ADDENDUM NO. 2

HELENA FIRE STATION #3

PROJECT: Helena Fire Station #3
Helena, Montana

ARCHITECT: DOWLING Architects
734 North Last Chance Gulch
Helena, MT 59601
406-457-5470

ENLARGED GRADING PLAN

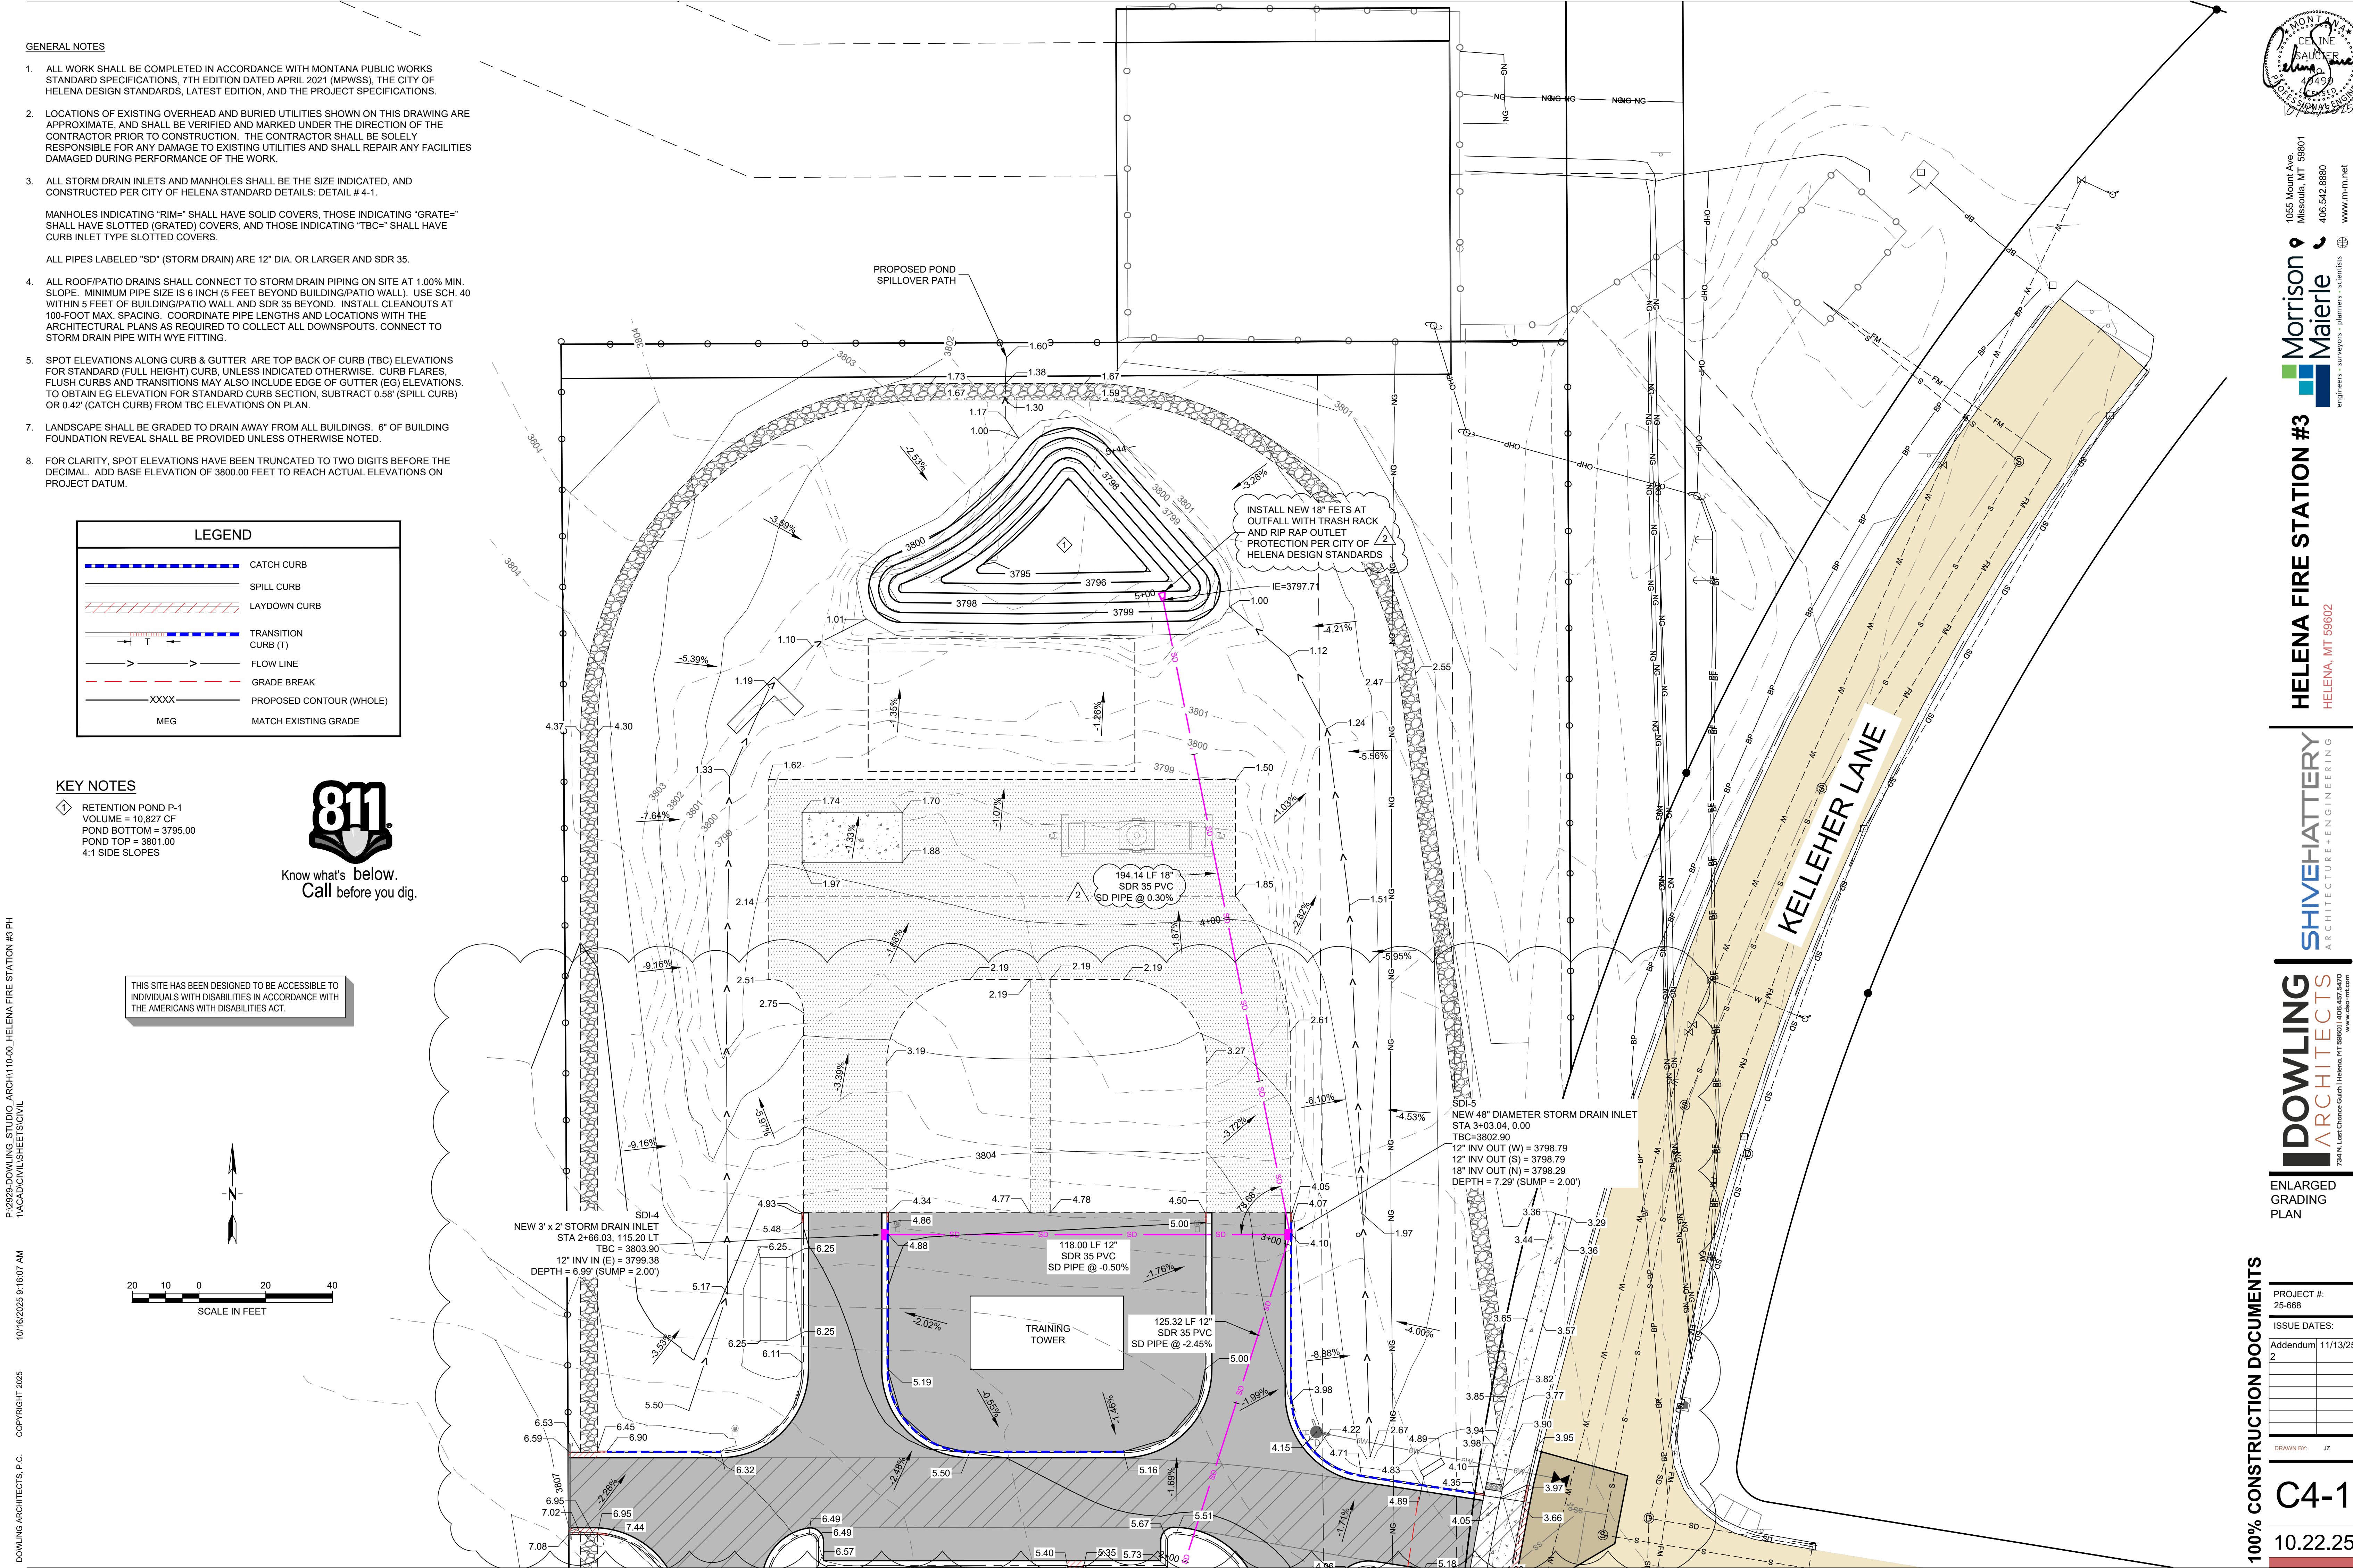
- **Sheet C3-2 Enlarged Site and Utility Plan** – Added heavy duty concrete pad to Diesel Storage and Backup Generator
- **Sheet C4-1 Enlarged Grading Plan** – Regraded Training Tower adjacent asphalt, regrading area north of access drive – rim elevations for SDI-4 and SDI-5 revised, upsized storm pipe after SDI-5 from CoH Stormwater Division conveyance comments

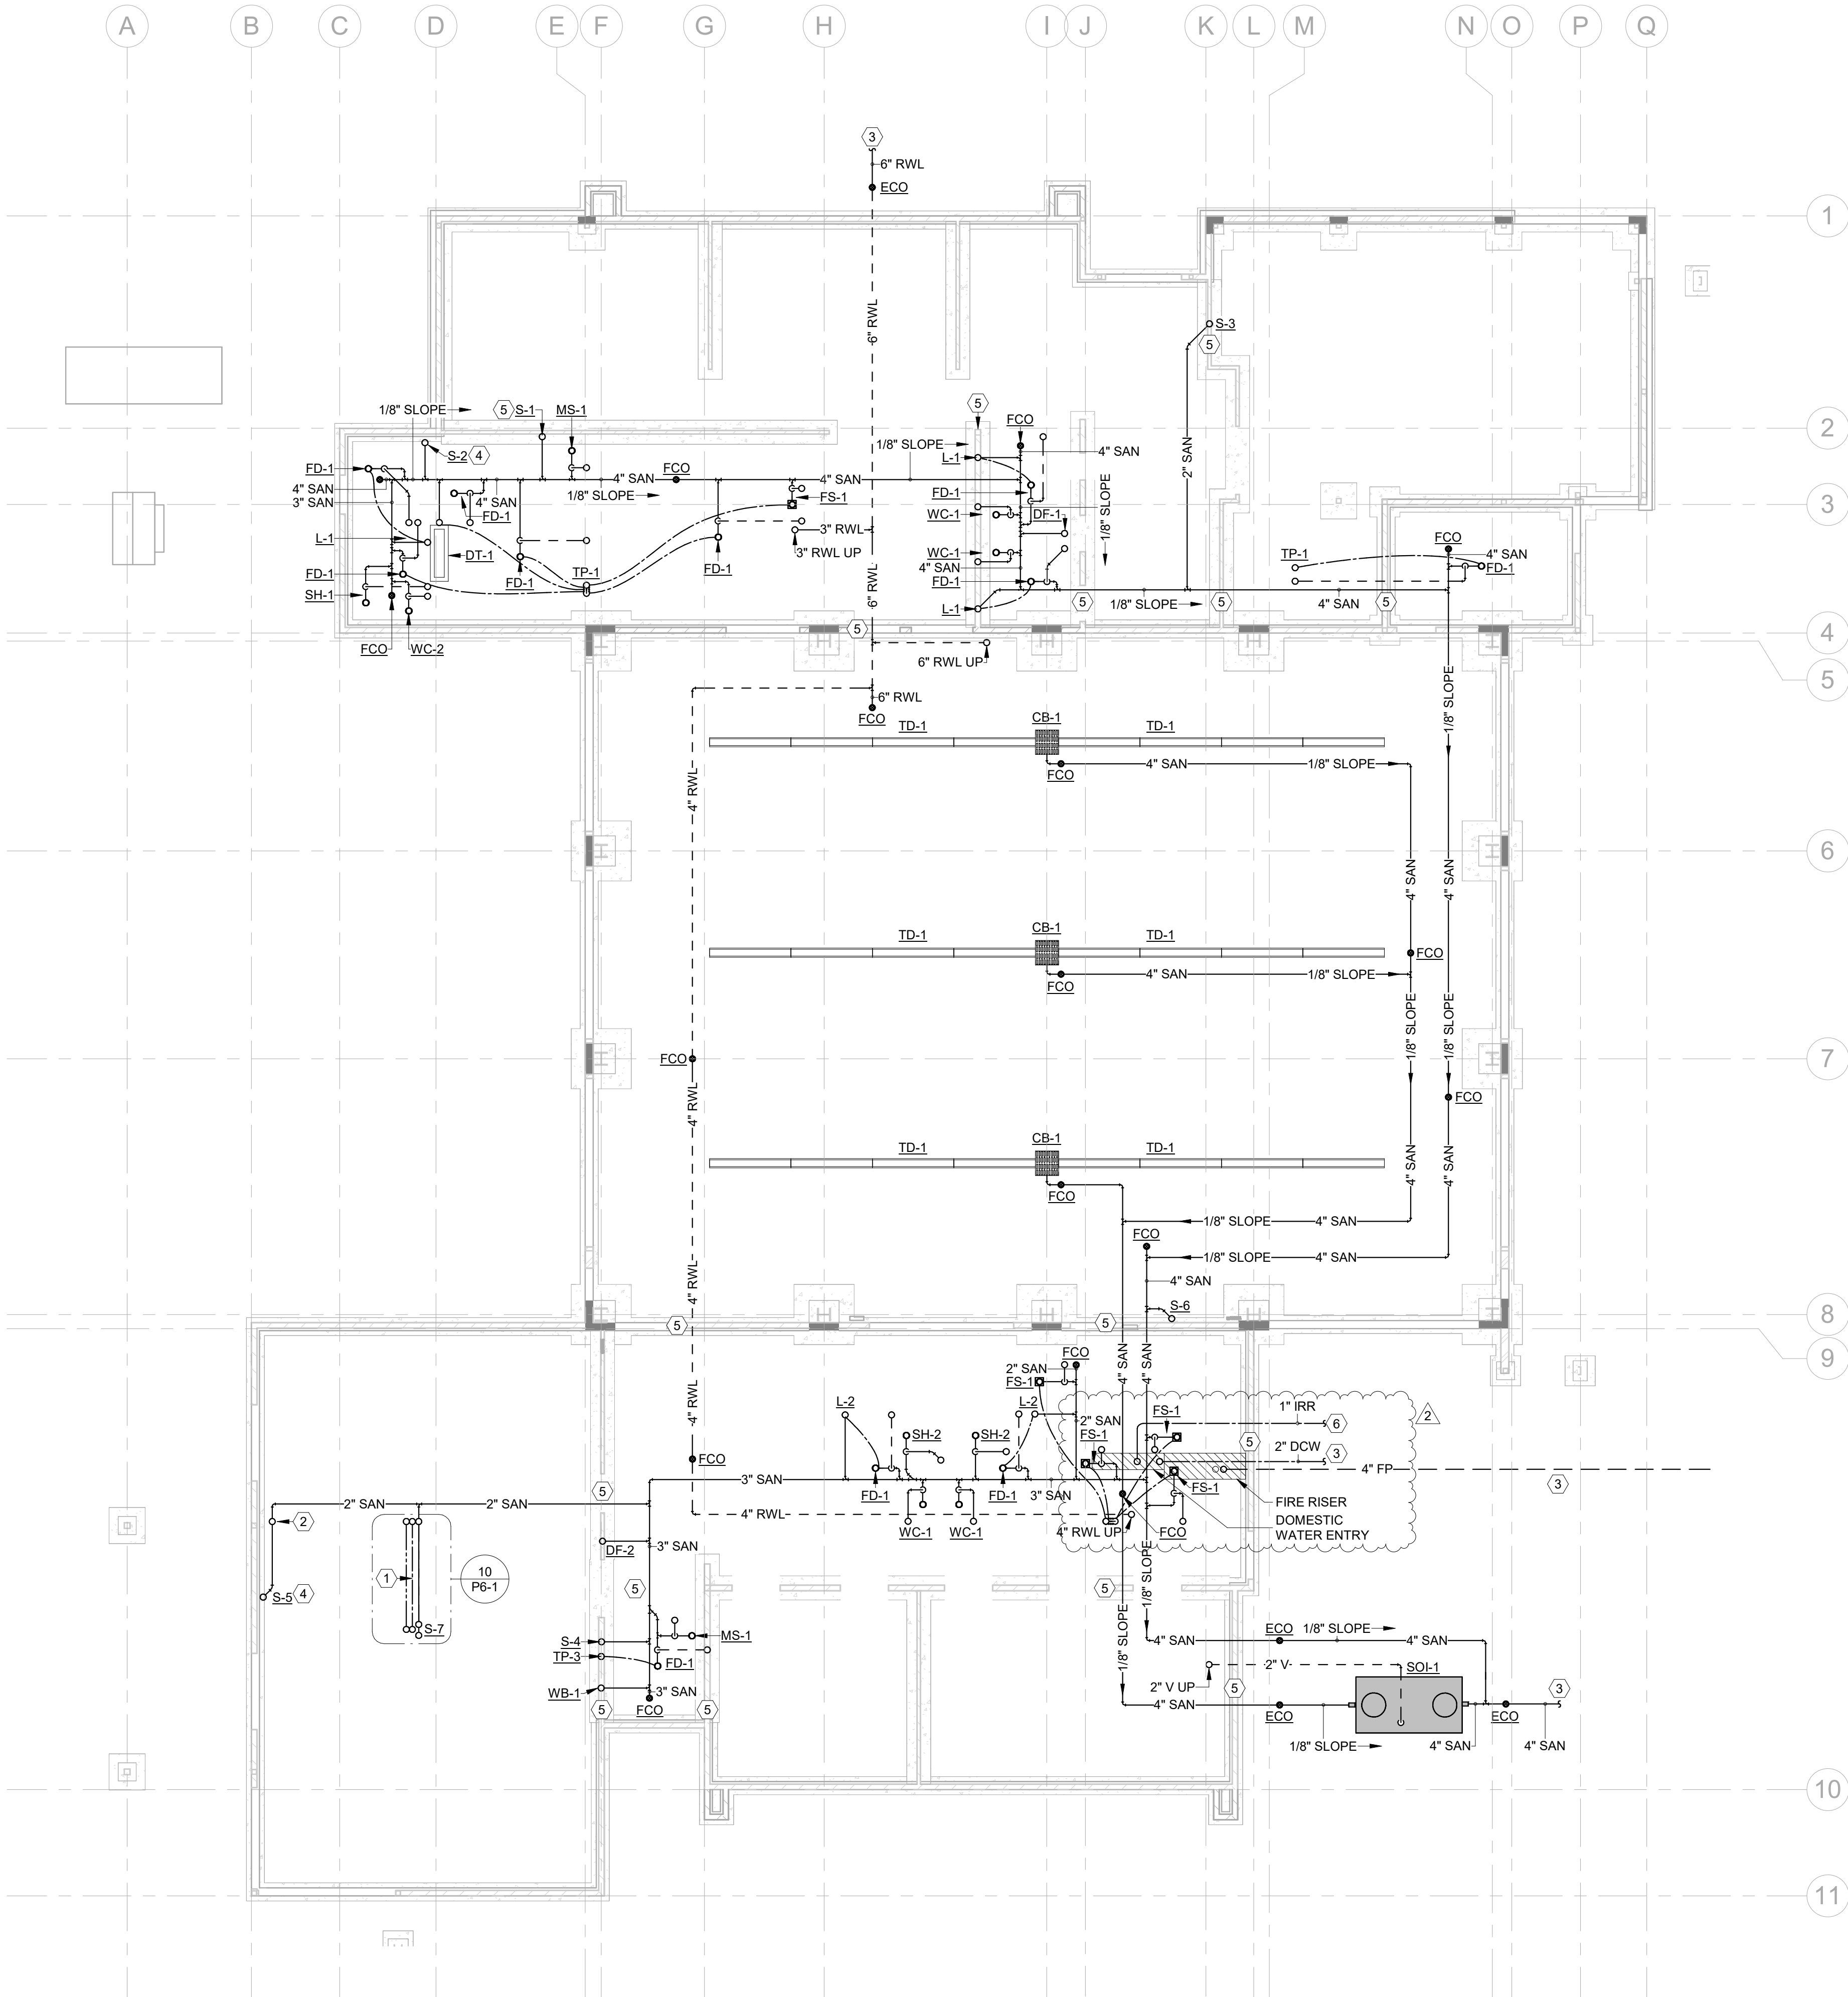
- **Sheet E2-6 Electrical Schedules** – Clarification/ revision to panel L1 for added loads.
- **Sheet E2-7 Electrical Schedules** – Show spare circuit on panel L2 and M2 for circuits moved to L1.
